DOCUMENTATION TRANSMITTAL

Transmittal No: CIO-0043
Date: May 12, 1984

Documentation Description: Nonconformance Reports:

RECORD COPY ^{EX}
NONCONFORMANCE REPORT

2 ITEM DRAWING/PART NO. FSK-M-2HBC-552-1 REV. 0	3 ITEM PART NAME SOCKET WELD AT FW#3	4 ITEM SERIAL NO. N/A
--	---	--------------------------

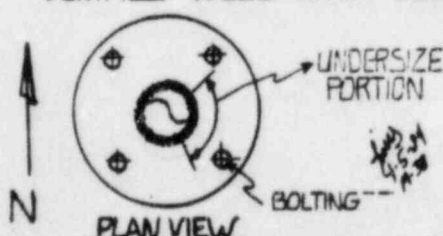
12 REQUIREMENT
PQCI-P-1.90 REV 1 ACT#3.10C STATES: SOCKET WELD SIZES SHALL BE DETERMINED IN ACCORDANCE WITH TABLE 3.
TABLE 3 STATES THAT FOR 1" PIPE, SCH. 80, THE WELD SIZE (PIPE TO FLANGE) SHALL BE .2506".

13 NONCONFORMANCE
CONTRARY TO THE ABOVE REQUIREMENTS, SOCKET WELD #3 ON LINE 1-2HBC-552 ON DRAWING FSK-M-2HBC-552-1 REV.0 IS UNDERSIZED.
VERIFIED WELD WITH DECIMAL GAUGE .2506 S/N# FG-.035.

31A ADDITIONAL INFORMATION FIELD ENGR RECOMMENDS REWORK OF WELD PER - G-27 AND SPEC M 204 REV 21 SECTION 5.4.4. TODD GROTH 4/18/84
R. GEURICH 4/25/84

0-00753-V
Rev. 3
of 3
LWA 4-13-84

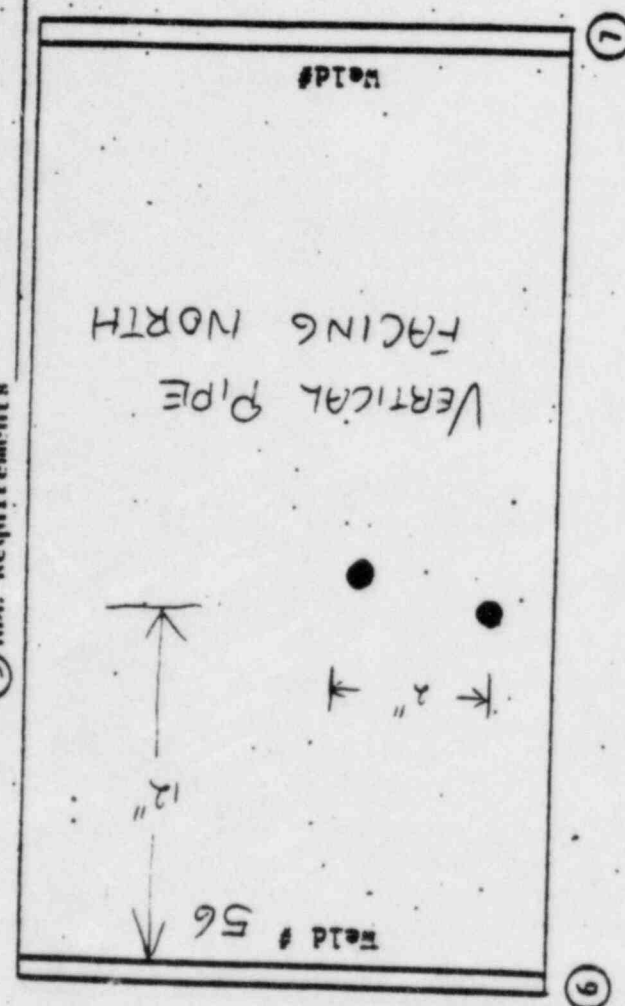
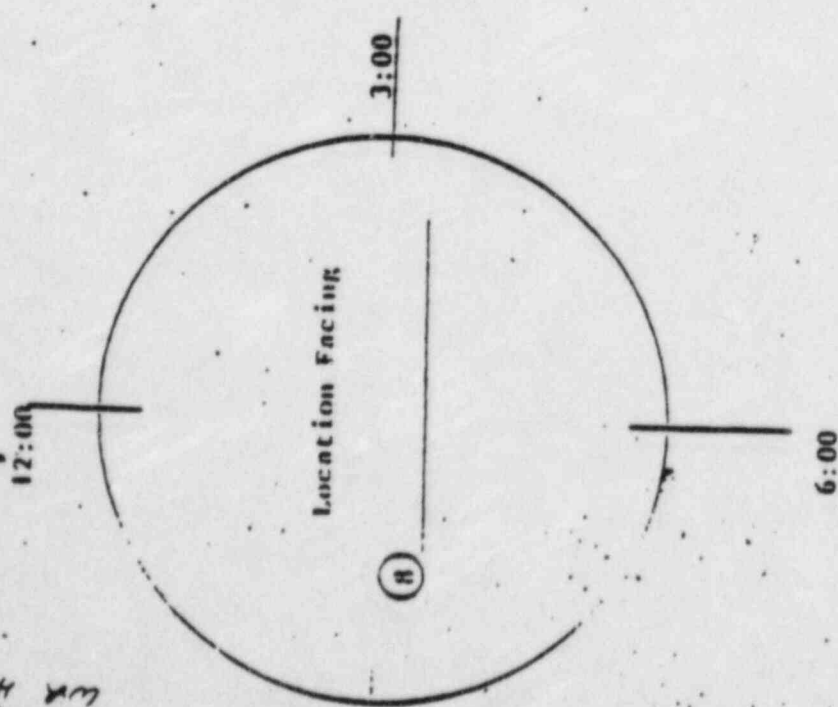
12 REQUIREMENT G27 ED-1 REV-2 STATES IN PART, ARC STRIKES WHICH ARE DETECTED VISUALLY WHICH ARE NOT ASSOCIATED WITH A SPECIFIC WELD MAY BE EVALUATED VISUALLY. ARC STRIKES AREAS WHICH ARE FREE OF CRACKS AND DO NOT INFRINGE UPON MINIMUM WALL THICKNESS MAY BE USED AS IS. FOR PDC I REQUIREMENTS SEE ACTIVITY 3.17.

13 NONCONFORMANCE CONTRARY TO THE ABOVE, ON SPOOL 2 OBC-2-S-634-4-1, TWO ARC STRIKES EXIST. DUE TO METAL BUILD-UP AT THE CENTER OF BOTH ARC STRIKES CRACKING IS INDETERMINATE. SEE ATTACHED PAGE FOR LOCATION

NCE NO. C-02891-V

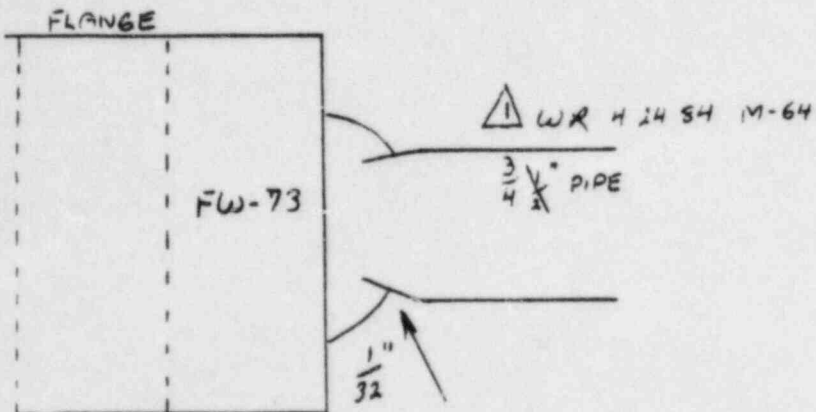
12 REQUIREMENT M-481 REV 25 NOTE 22, STATES IN PART, WHERE THREADED CONNECTIONS ARE SEALWELDED - - - - EXPOSED THREADS SHALL BE ENTIRELY COVERED BY WELD METAL.
M-204 REV-21 STATES IN PART, (PARA 5.2.6) MINIMUM WALL THICKNESS FOR FABRICATED ASSEMBLIES AS FINALLY FABRICATED SHALL BE AT LEAST:
A. 87 1/2% OF THE NOMINAL WALL THICKNESS FOR PIPE SPECIFIED BY NOMINAL WALL.
FOR PCCI REQUIREMENTS SEE ACTIVITY 317 LI. A KLR 4-24-84 (M-G)

13 NONCONFORMANCE CONTRARY TO THE ABOVE, AT FW-73 THE EXPOSED THREADS WERE REMOVED BY GRINDING, REDUCING THE BASE METAL FROM THE $\frac{3}{4}$ " PIPE IN EXCESS OF $\frac{1}{32}$ " AT THE TOE OF THE WELD, WHICH EXCEEDS THE DEPTH ALLOWANCE OF .019" AND VIOLATES MIN-WALL.
